TALKO VIDEO DETECTION SYSTEM ON T.H. 169 FROM 148D FT. WEST OF C.S.A.H 80 TO 1200 FT. EAST OF C.S.A.H 80

LAYOUT No.: 1B, COPY No.: 1

Level 2 LAYOUT APPROVAL

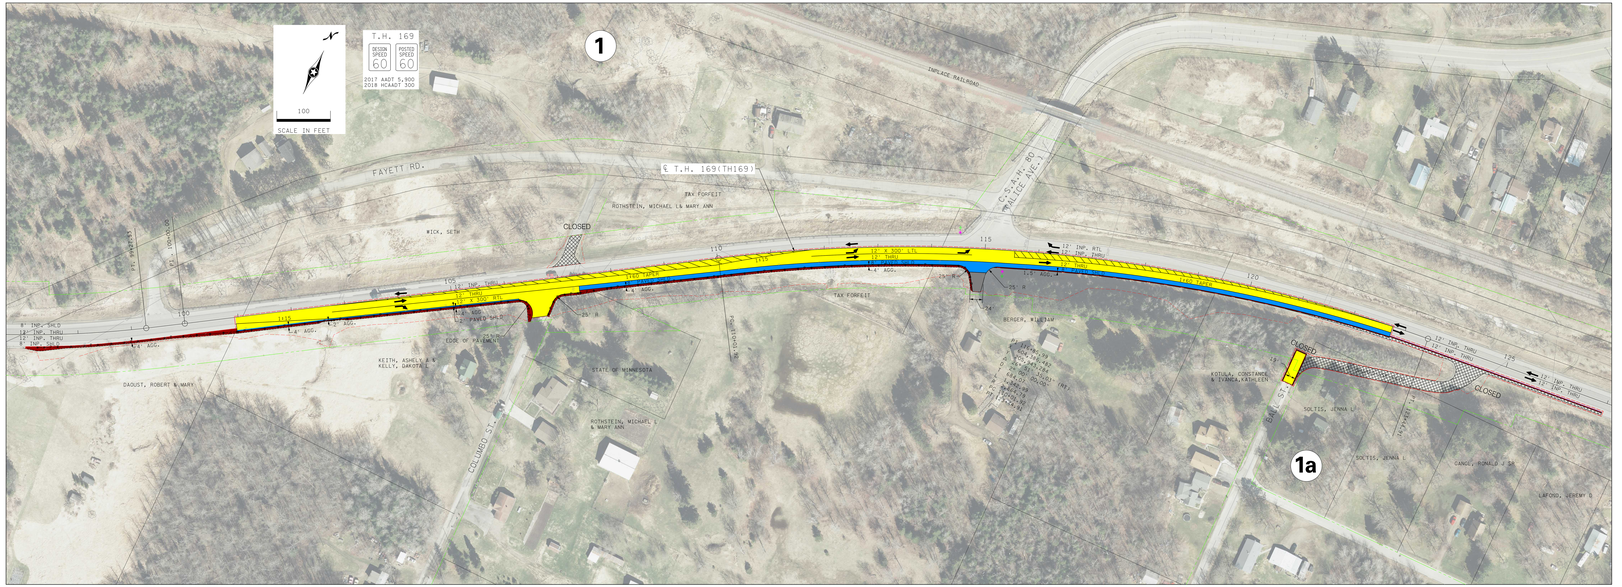
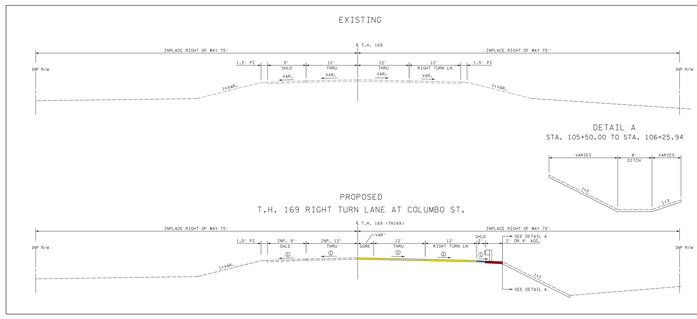
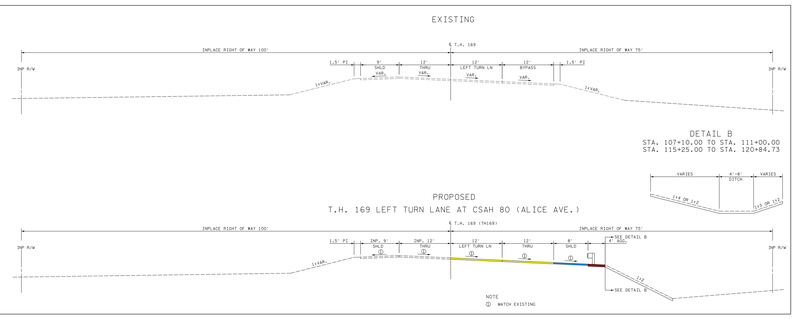
UPDATED LAYOUT TO REMOVE THE PROPOSED PEDESTRIAN CONNECTION BETWEEN BALL STREET AND T.H. 169 TO ADDRESS LANDOWNER SAFETY CONCERNS RELATED TO ATV/SNOWMOBILE TRAFFIC ALONG BALL STREET. THIS HAS ADVANCED THE LAYOUT TO 1A.

UPDATED LAYOUT WITH THE FOLLOWING REVISIONS:
- A 2-FOOT PAVED SHOULDER BETWEEN THE RIGHT TURN LANE ONTO COLUMBO ST. AND THE PROPOSED GUARDRAIL WAS ADDED;
- THE PROPOSED T.H. 169 SHOULDER WIDTH WHERE NO GUARDRAIL IS PRESENT WAS REVISED.
- THE PROPOSED TYPICAL SECTIONS AND DITCHES WERE REVISED.

THIS HAS ADVANCED THE LAYOUT TO 1B.
